## **REQUEST FOR BID No. 16-003** **Addendum No. 2** December 29, 2015

**Peach County Workforce Development Center Irrigation**  
**425 James E. Khoury Blvd., Fort Valley, GA**

**ADDENDUM 2:**

PROJECT NO.	982.03
DATE	06/19/2015
SHEET TITLE	IRRIGATION PLAN
CHECKED BY	ZT
SHEET NO.	IR-1

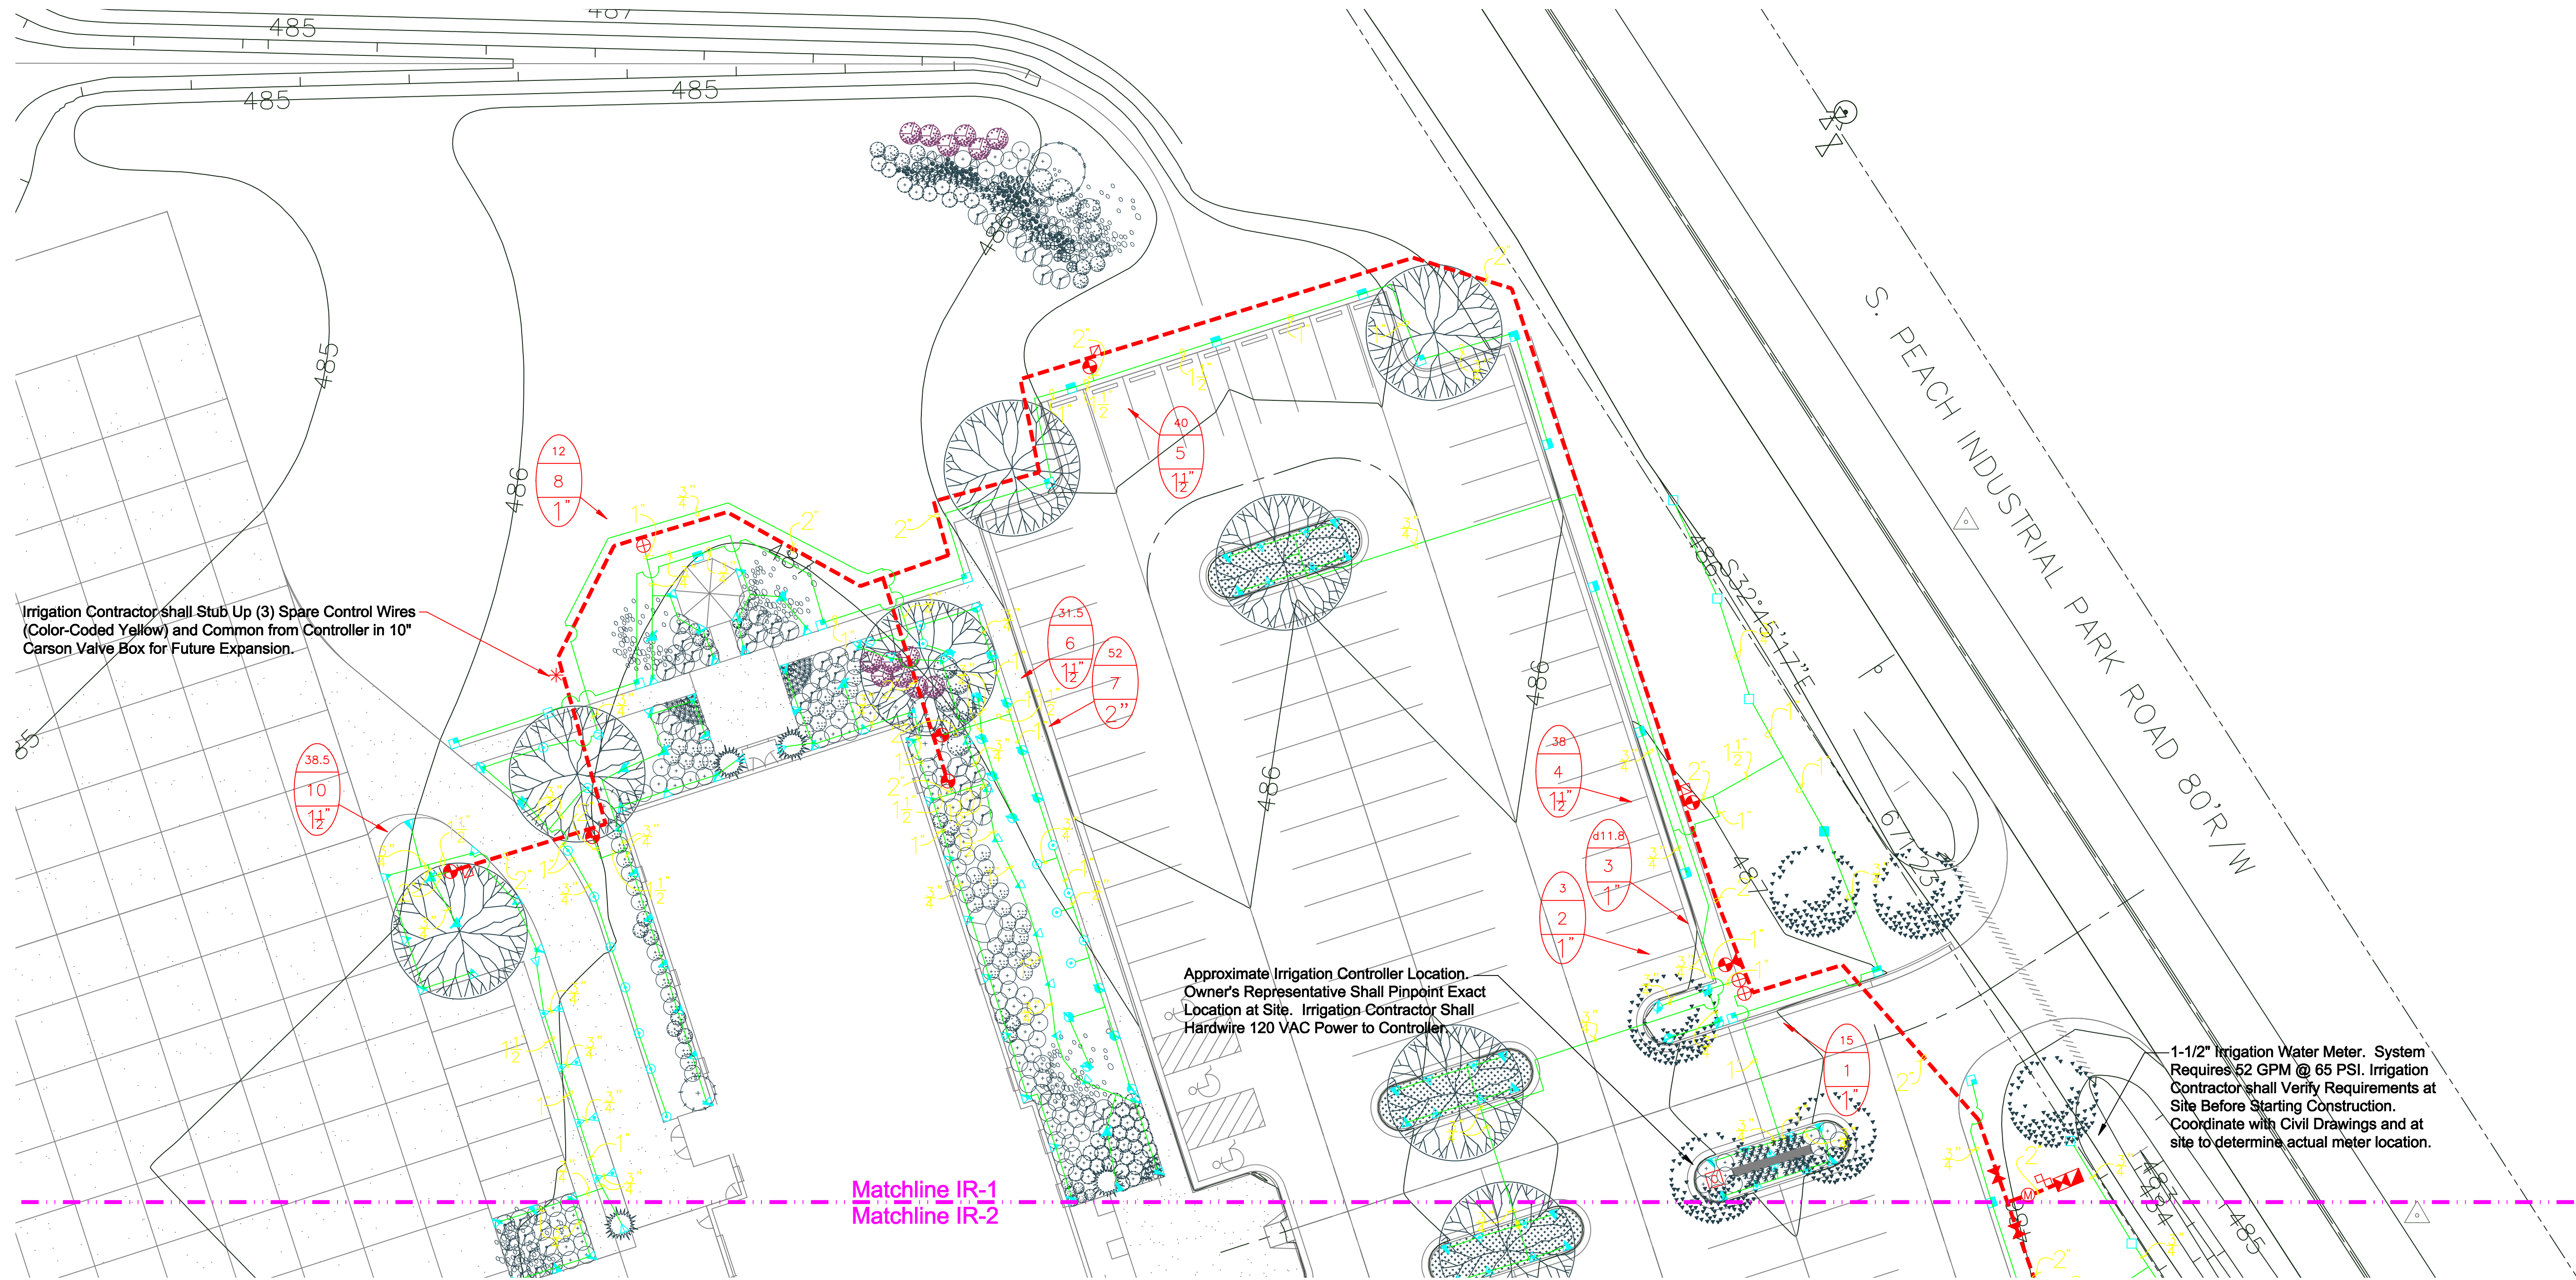
**REVISION NOTE:**

- USE THIS PLAN AS A GUIDE FOR INTENT. CONTRACTOR SHOULD SPEC EQUIPMENT THAT PROVIDES BEST VALUE FOR OWNER. FOR EXAMPLE, HUNTER PGP ROTARS OR A BETTER VALUE THAN I-20 HEADS. CONTRACTOR SHOULD ADJUST PLAN INCLUDING NUMBER OF HEADS AND PIPE SIZES, ETC. TO SERVE EQUIPMENT CONTRACTOR SELECTS. OWNER WILL BE LOOKING FOR COST SAVINGS WHILE SERVING IRRIGATION NEEDS TO ESTABLISH PLANT MATERIAL. SEE REVISED PLANTING PLAN FOR SPECIFIC NUMBER OF PLANT MATERIALS AND THERE LOCATION. DO NOT USE THIS PLAN FOR PLANTING AS IT IS NOT CURENT PLAN. IRRIGATION EQUIPMENT MANUFACTURER CAN BE ADJUSTED/CHANGED AS RECOMMENDED BY CONTRACTOR TO PROVIDE COST SAVINGS.

PROJECT NO.	982.03
DATE	06/19/2015
SHEET TITLE	IRRIGATION DETAILS
CHECKED BY	ZT
SHEET NO.	IR-4

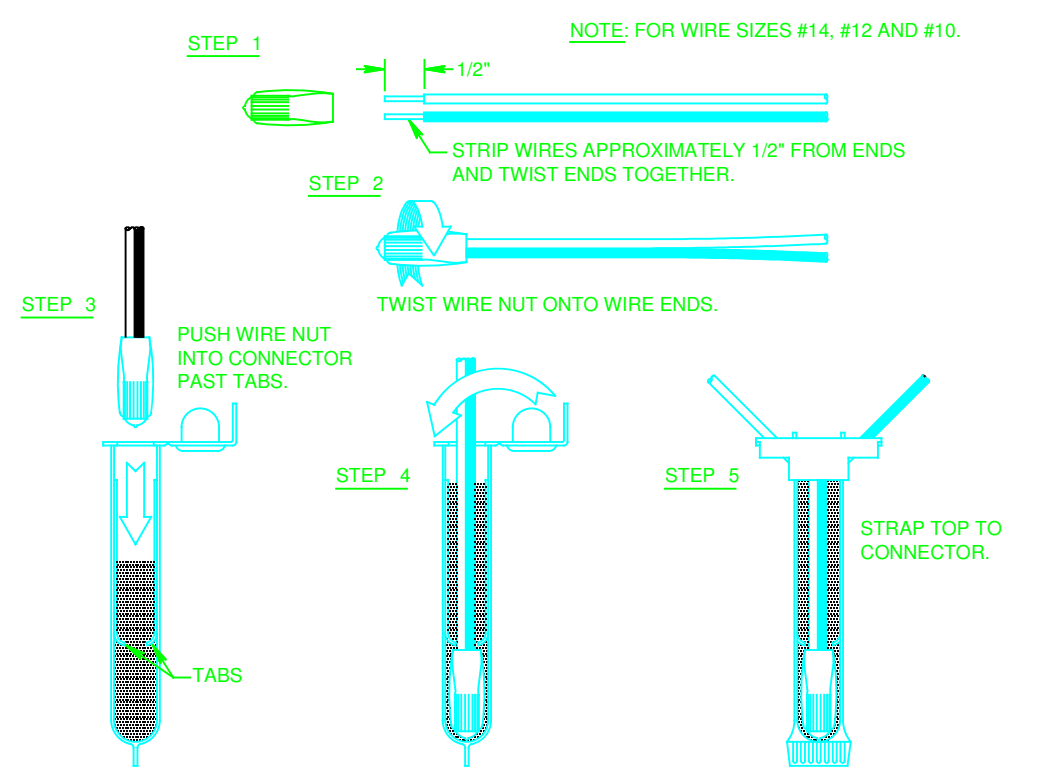
### REVISION NOTE:

1. USE THIS PLAN AS A GUIDE FOR INTENT. CONTRACTOR SHOULD SPEC EQUIPMENT THAT PROVIDES BEST VALUE FOR OWNER. FOR EXAMPLE, HUNTER PGP ROTARS OR A BETTER VALUE THAN I-20 HEADS. CONTRACTOR SHOULD ADJUST PLAN INCLUDING NUMBER OF HEADS AND PIPE SIZES, ETC. TO SERVE EQUIPMENT CONTRACTOR SELECTS. OWNER WILL BE LOOKING FOR COST SAVINGS WHILE SERVING IRRIGATION NEEDS TO ESTABLISH PLANT MATERIAL. SEE REVISED PLANTING PLAN FOR SPECIFIC NUMBER OF PLANT MATERIALS AND THERE LOCATION. DO NOT USE THIS PLAN FOR PLANTING AS IT IS NOT CURRENT PLAN. IRRIGATION EQUIPMENT MANUFACTURER CAN BE ADJUSTED/CHANGED AS RECOMMENDED BY CONTRACTOR TO PROVIDE COST SAVINGS.

**SITE PLAN -  
ELECTRICAL**

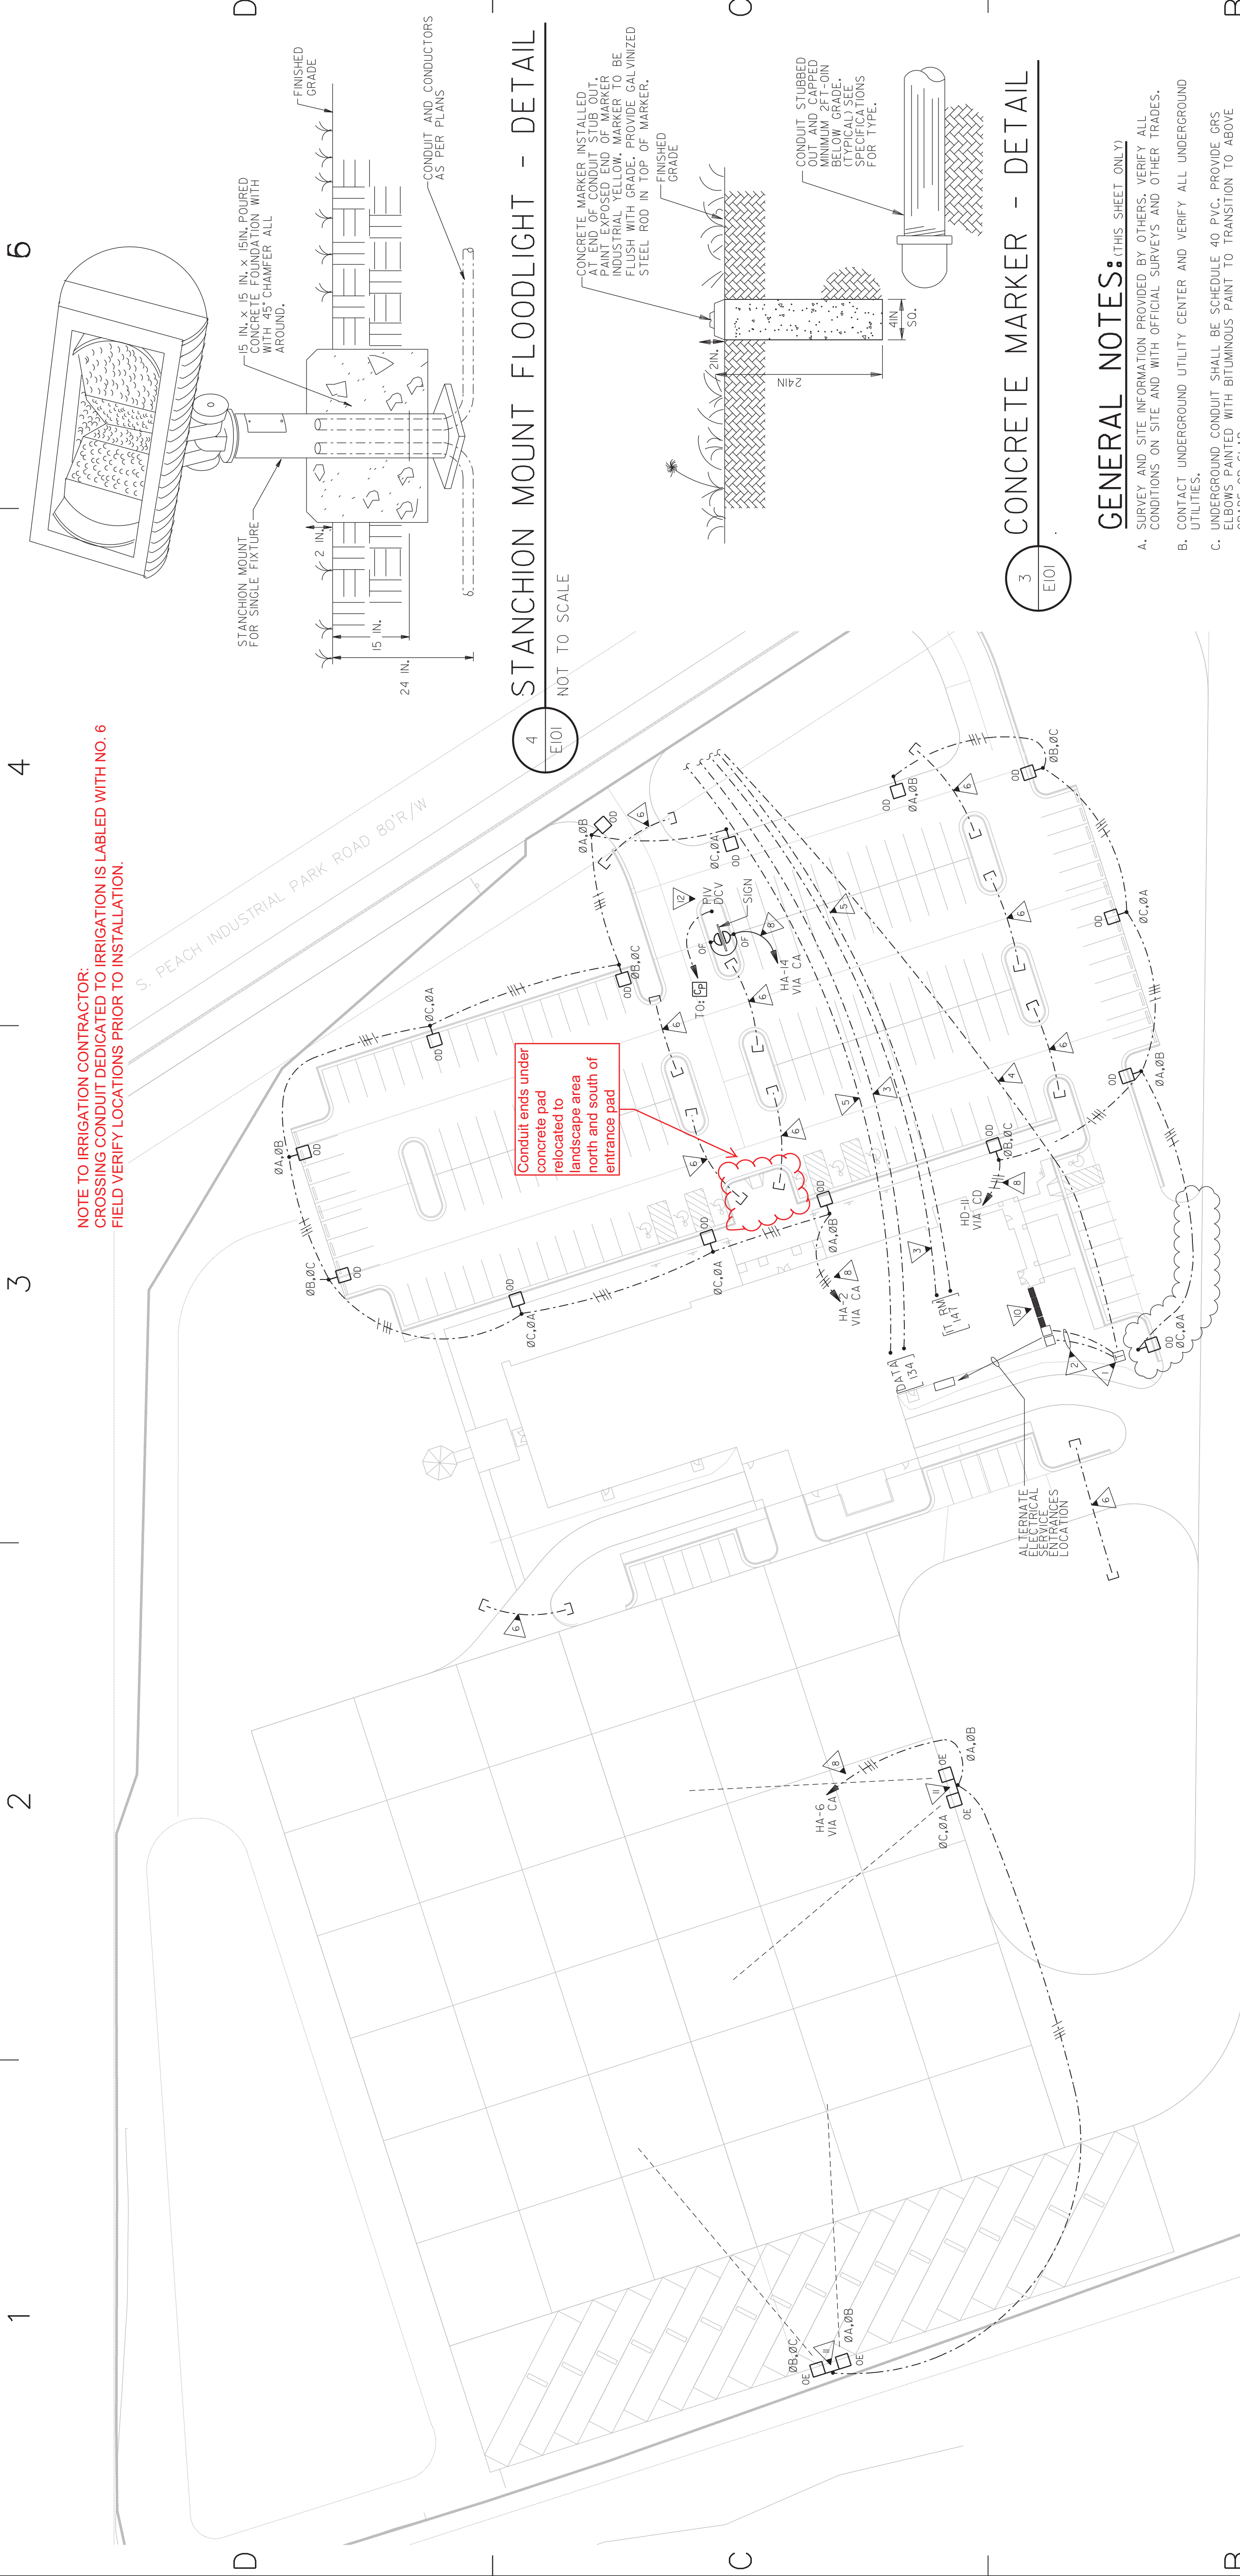
### **3. Pavement Crossings Clarification (Exhibit A2-2) :**

All road and parking lot pavement crossings shall be bored unless pipe conduit for crossings dedicated to irrigation have been installed previously. Sidewalks pavement crossings may be installed only by removing and replacing entire sections of sidewalk between construction joints, or shall be bored, unless pipe conduit for crossings dedicated to irrigation have been installed previously. No cutting of pavement will be allowed. Refer to attached electrical plan for sketch of planned irrigation conduits. Contractor shall field verify actual locations.

**NOTE TO IRRIGATION CONTRACTOR:**  
CROSSING CONDUIT DEDICATED TO IRRIGATION IS LABELED WITH NO. 6  
FIELD VERIFY LOCATIONS PRIOR TO INSTALLATION.
